Re: Order No. R-1470
Twin Lakes Lease

Herewith is enclosed a plat showing the present producing and injection wells on the Twin Lakes flood in the Artesia Pool, Exhibit No. 1. Also enclosed is graph showing the production, water injection, and water production since the start of the flood, Exhibit No. 2.

Re: WFX No. 98-Twin Lakes Flood
And The Red Lake Premier
Sand Flood, Harold Kersey

TWIN LAKES WATERFLOOD

Exhibit No. 1.

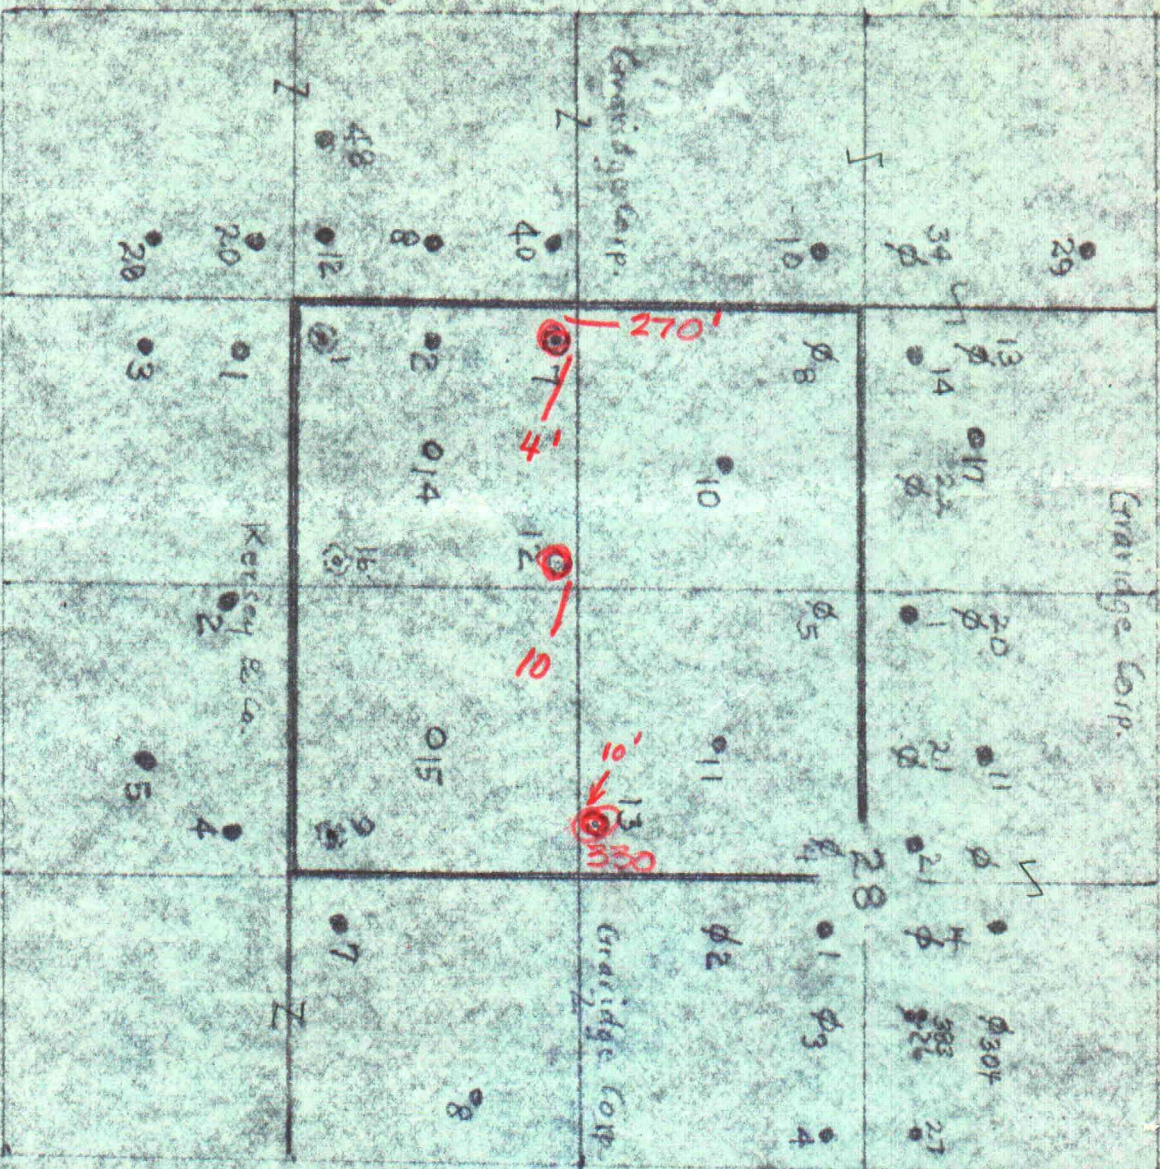
I find what appears to be an error in the description of a well location in WFX 98. The Twin Lakes well No. 13 is actually located in unit K, NE/4 SW/4, rather than the NW/4 SW/4 as described in the order. Will a revised order be issued?
